**SECTION 4.55(2) MODIFICATION
FORT STREET PUBLIC SCHOOL (SSD 10340)**

This application has been prepared by Ethos Urban on behalf of School Infrastructure NSW (SI NSW) pursuant to section 4.55(2) of the *Environmental Planning and Assessment Act 1979* (EP&A Act) to modify Development Consent SSD 10340 relating to the redevelopment of Fort Street Public School.

Figure 3 Removal and relocation of the Met Building lift

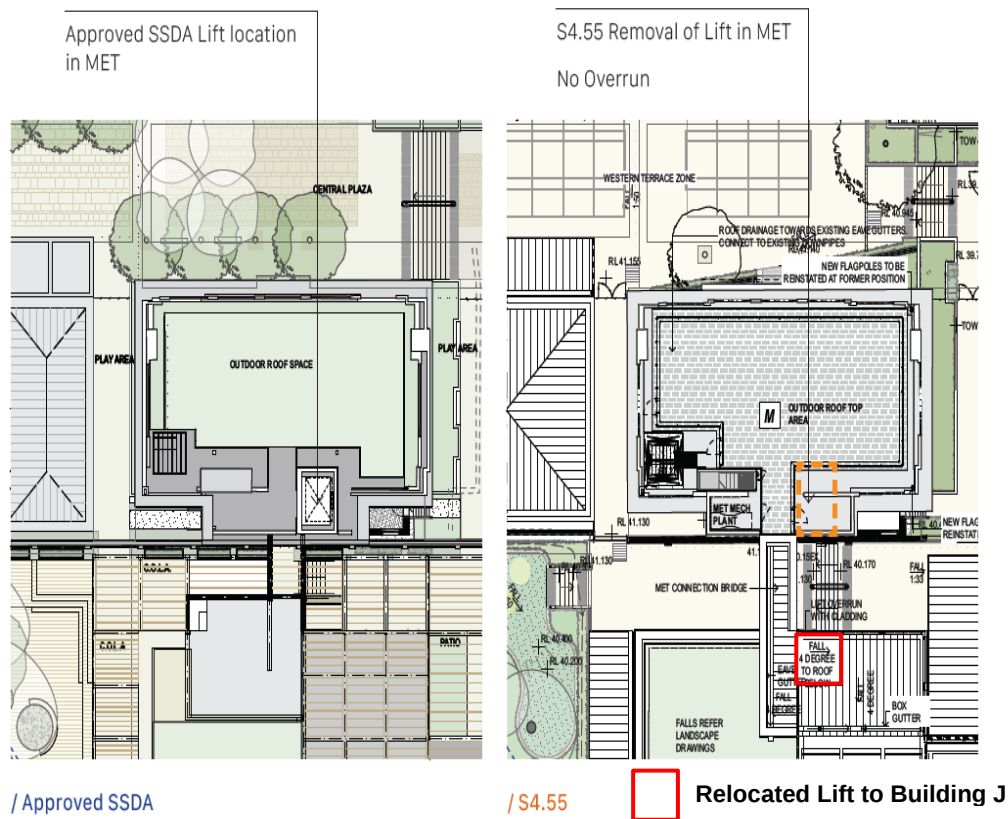
The lift core in the Met Building has been removed following detailed dilapidation investigations of the existing Met Building fabric and further consideration of costs. The lift core has been relocated to the north-eastern corner of Building J, which will be connected to the Met Building rooftop via a new covered bridge. This is illustrated in **Figure 3** and **Figure 4**. Removal of the lift from the Met rooftop eliminates the lift overrun, hence resolving the concerns raised regarding the impact to the heritage building and affect upon amenity.

Figure 7 Plan showing removal of Building G Lower Ground Level and reduction in OSD footprint

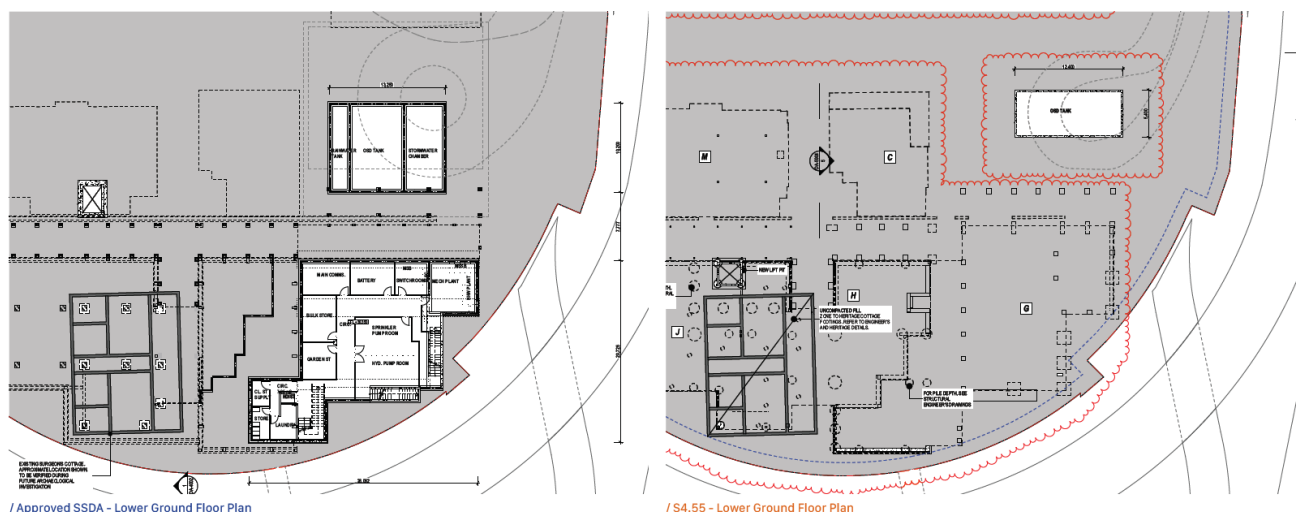
The Lower Ground Level in Building G contained various plant and services. The building services strategy has been rationalised, allowing the Lower Ground Level to be removed, as shown in **Figure 7**. Its removal is a result of the removal of the sprinkler system and refinement of electrical supply analysis and offsetting this with rooftop PV cells. This has allowed for a reduction in the infrastructure required. Consequently, the extent of excavation required is significantly reduced.

The volume and footprint of the OSD below the eastern forecourt is proposed to be reduced, due to the installation of new supplementary satellite rainwater tanks around the perimeter of the buildings at ground level, within the landscaped areas. The footprint of the OSD will be reduced from 135m² to 66.96m². This is shown above in **Figure 7**.

Figure 8 Plan showing changes to PV cell layout and addition of mechanical plant on the roof of Buildings A and D

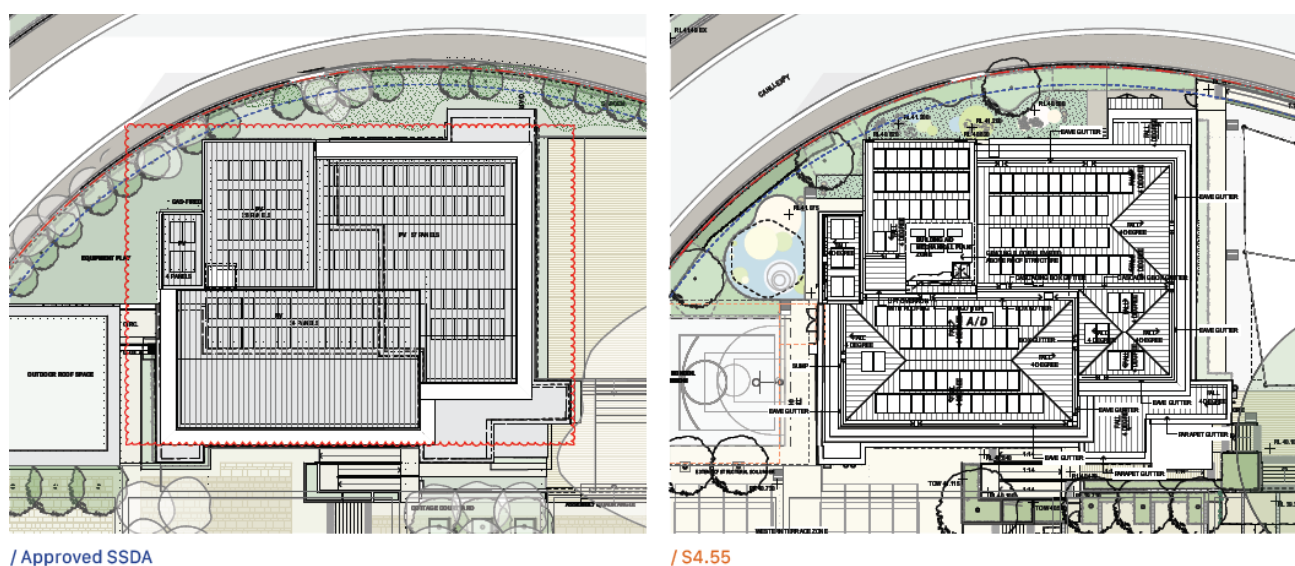
The PV cell layouts on the roof of Buildings A and D have been revised, and the number of PV panels has been reduced from 155 panels to 134 panels following detailed services coordination and development. The required 40kw energy generation is maintained.

Mechanical plant condensers have been relocated from various ground floor locations to the roof level. They are setback from the perimeter of the roof to mitigate visual impacts.

Figure 10 Comparison of approved and proposed materiality of the COLA and colonnade forms

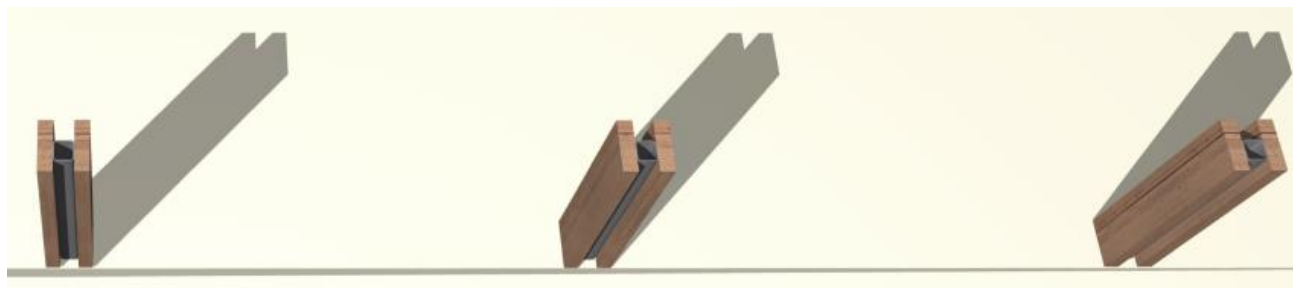
The materiality of the COLA and colonnade forms is proposed to be changed from timber frames to a hybrid structure steel and timber structure due to load bearing and structural design requirements, as shown in **Figure 9**. The structural load bearing elements will be constructed of steel and painted with a durable Interthane industrial paint system using subdued colours. The timber 'look' of the approved scheme will be retained in the form of decorative timber-based cladding elements that will be applied to the columns and horizontal beams of the colonnade and COLA structures. A comparison of the approved and proposed materiality is shown in **Figure 10**.

Figure 11 Comparison of approved and proposed materiality of the Building F, G, H and J piers and parapets

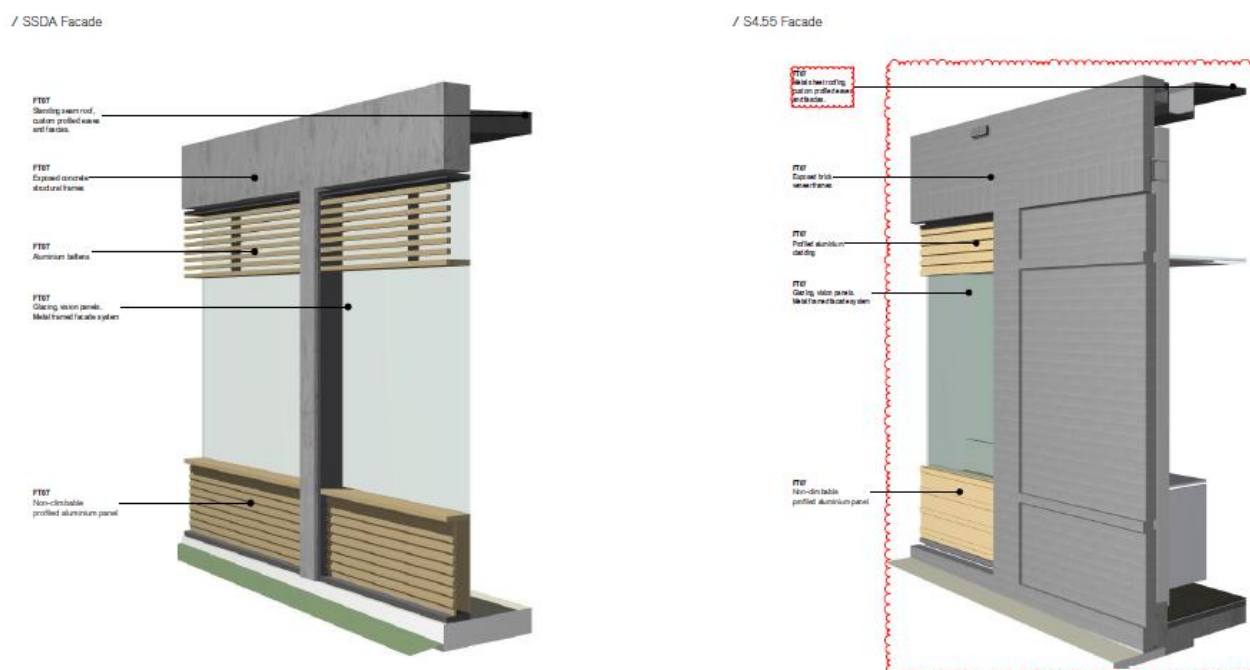
Further, the materiality of the piers and parapets of Buildings F, G, H and J is proposed to be modified from exposed concrete facades to exposed brickwork, as shown in **Figure 11**.

Figure 12 Plan of Upper Fort Street and new Bradfield Shed

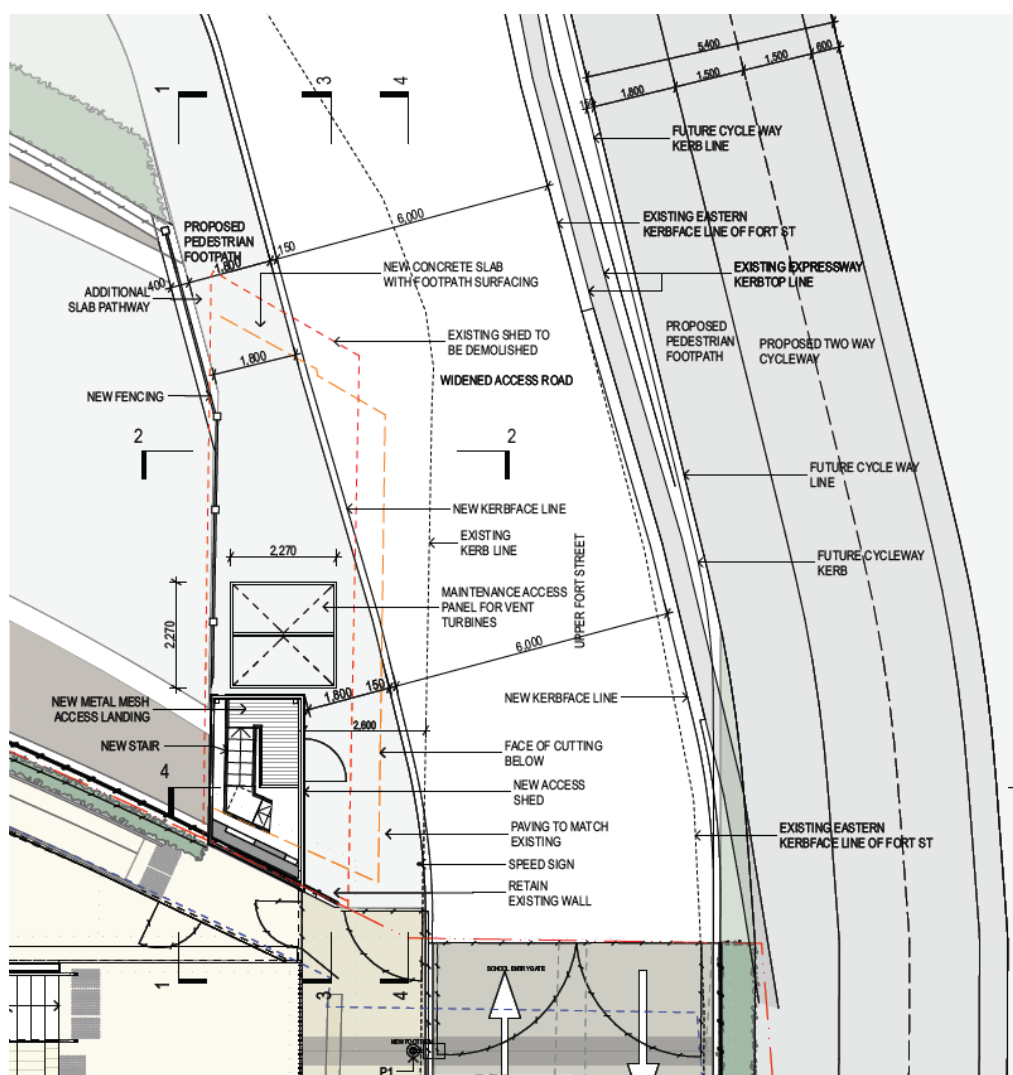
- Retention of the eastern kerb, vehicle fence and concrete upstand to the Bradfield Expressway at Upper Fort Street immediately in front of north-east boundary corner.
- Adjustment to the width of Upper Fort Street to a constant 6m, and removal of the previous pinch point/tapering of kerb-to-kerb dimension to suit 6m.
- Minor revisions to the footprint of the shed enclosure and verification of existing stairways, as verified against a point cloud survey.
- Revision of the end-of-life replacement access hatch.

Figure 13 Proposed Phase 1 and 2 Pick-up/Drop-off Arrangements

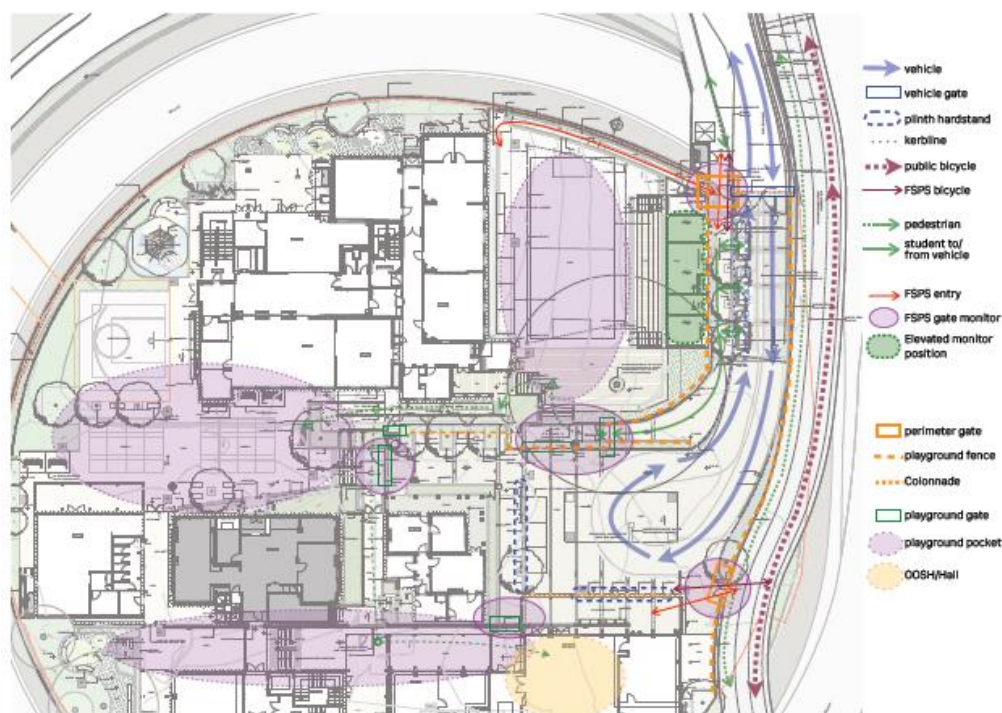
Modification	Phase 1	Phase 2
A new school entry gate and ramp at the north-eastern corner of the site adjacent to the Bradfield Services Shed. This will alleviate the pressure at the school's current eastern entry/exit points and separate students arriving from the north of the school from the pedestrians and vehicles on the loop road. A teacher or traffic warden will be able to supervise this gate from the elevated monitor position of the amphitheatre terrace at drop-off and pick-up times.	Yes	Yes
Segregated pedestrian and cyclist crossing of Upper Fort Street during Phase 1. This will separate cyclists and pedestrians where the Western Distributor shared path meets Upper Fort Street. Cyclists will use the eastern side of the path to continue along the Upper Fort Street/Western Distributor shared path while pedestrians will cross Upper Fort Street on the western side of the path. This will also enable public pedestrian movements to occur away from the school's pedestrian entry gates. This does not apply to Phase 2 as the new Sydney Harbour Bridge Cycleway will be separated from Upper Fort Street.	Yes	N/A

Pick-up and Drop-off point for Phase 2 will be located along Upper Fort Street adjacent to the school. Vehicles will still use the loop in the school playground, but there will be no stationary pick-up or drop-off within the school playground.	N/A	Yes
New hardened playground seats along the western and southern perimeter of the school playground that act as physical barriers to add vehicular incident protection and improve visual cues to the drop-off and pick-up zone. reduce risk of out-of-control motor vehicles (illustrated as dotted blue lines in Figure 13).	Yes	Yes
Improvement of line markings, addition of various fences and gates, and Upper Fort Street crossing to better define user pathways.	Yes	Yes
Use of 'playground pockets', illustrated in purple in Figure 13 , as catchment areas to hold students during pick-up and drop-off times. Movements between the pockets are illustrated by green arrows in Figure 13 , demonstrating the ability to move flexibly students between the pockets behind physical obstructions that segregate vehicle movements and these access routes. Gateway improvements have also been conducted within the site to enable the pockets to function as holding areas.	Yes	Yes

Changes to the materiality of the school playground pavement to clearly demarcate zones for vehicles during pick-up and drop-off movements.	Yes	Yes
Straightening of roadway in front of the Services Amphitheatre building to improve sight lines around vehicles.	Yes	Yes

Figure 14 Proposed location of rainwater tanks

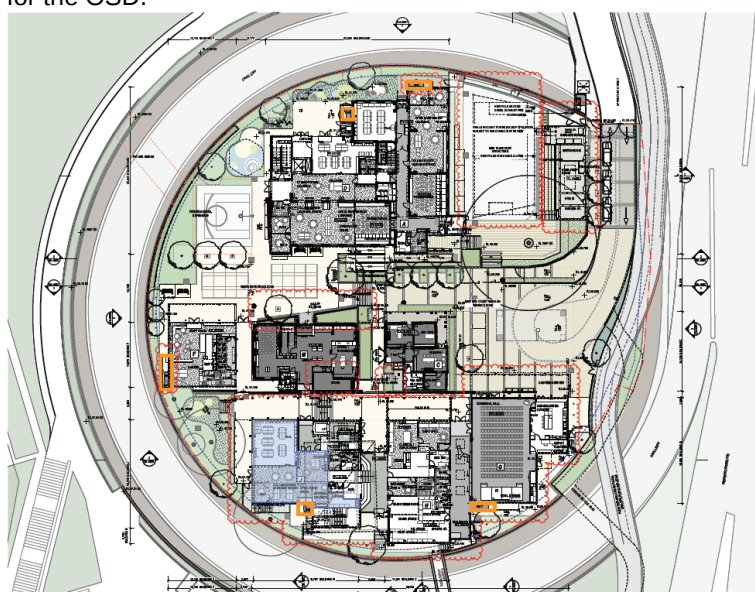
Supplementary rainwater tanks are proposed within screened enclosures around the perimeter of Buildings A, D and F and Buildings J, H and G as shown in **Figure 14** below. They will be fully enclosed by light weight cladding with an access door, as shown in **Figure 15** below. These have been introduced to reduce the costs and excavation for the OSD.

Figure 16 Revised lighting strategy

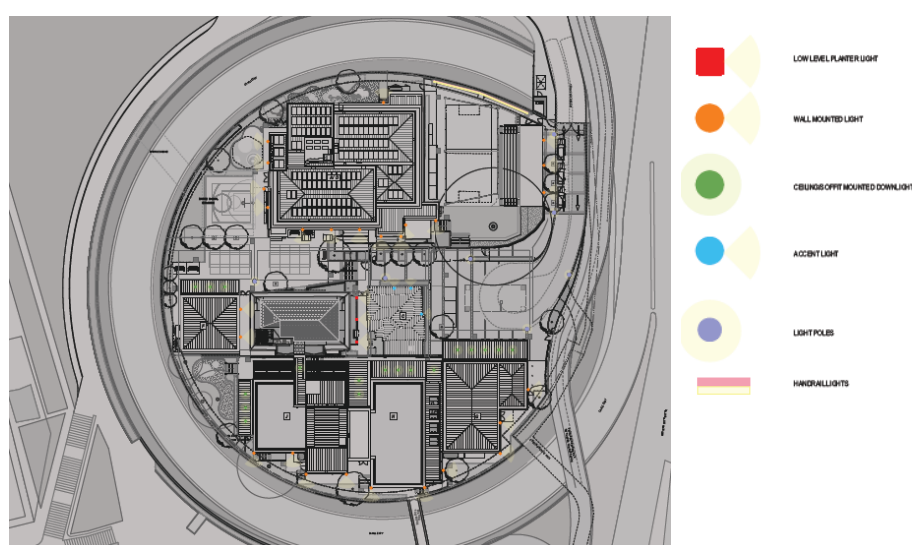
The external lighting strategy has been modified to reduce the scope of lighting. Key changes include deletion of lighting to the building rooftops, fewer pole top lights on the approach road and removal of building up-lighting. The proposed development continues to achieve the requirement to maintain a low-level of upward-facing light output and sensitive light fittings to respect the operation of the Sydney Observatory. The revised lighting strategy is shown at **Figure 16**.
